**SUBJECT:** Upper Rock Creek Area Master Plan – Adoption

MCPB No. 04-03

Resolution No.: 15-519  
Introduced: February 24, 2004  
Adopted: February 24, 2004

**SUBJECT:** Approval of Planning Board Draft Upper Rock Creek Master Plan

# Upper Rock Creek Special Protection Area

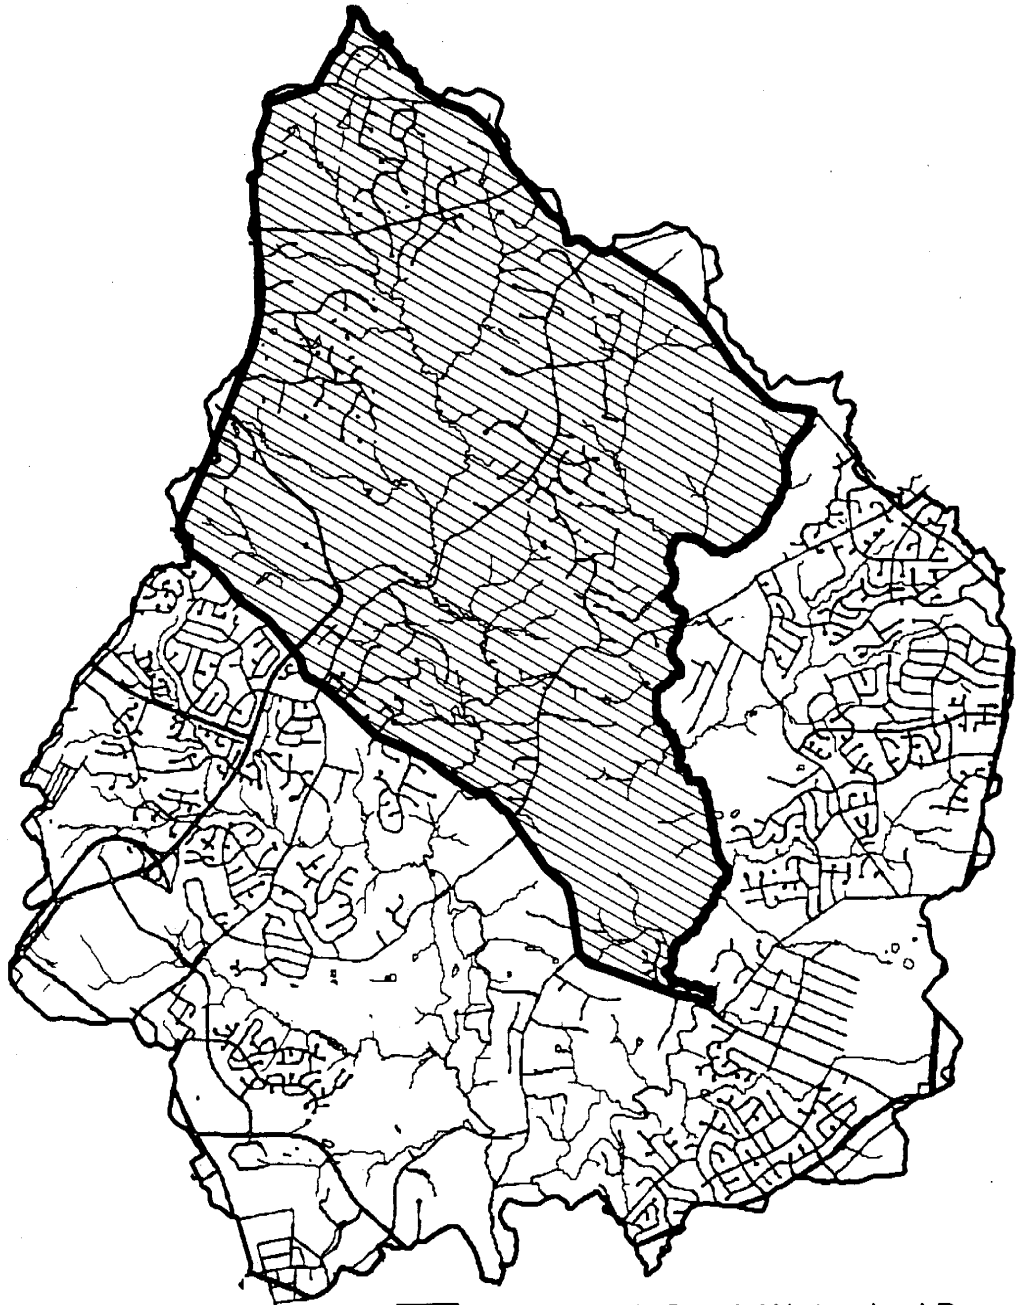
This Master Plan designates the Upper Rock Creek watershed within the Planning Area north of Muncaster Mill Road as a Special Protection Area (SPA). Some of the properties included in the SPA are specifically discussed in this Master Plan; others are not mentioned by name. All properties shown within the boundaries of the map on page XXX are designated as part of the SPA with the exception listed below. The existing water resources, including the Use III stream and associated forests and wetlands, are of high quality and unusually sensitive (see additional text in this chapter describing each resource). The proposed land uses have the potential to threaten these resources in the absence of special water quality protection measures that are closely coordinated with land use controls. The water quality review process would provide an opportunity to establish water quality goals for each development prior to design, provide better performance overall of best management practices through use of a sequential treatment strategy, and monitor water quality before, during and after construction to determine the effects of the development.

- Designate a Special Protection Area for the Upper Rock Creek watershed within the Planning Area north of Muncaster Mill Road.
- Establish an environmental overlay zone for all new development with sewer service within the Special Protection Area to implement an 8 percent imperviousness cap and to maintain low imperviousness levels throughout the watershed.
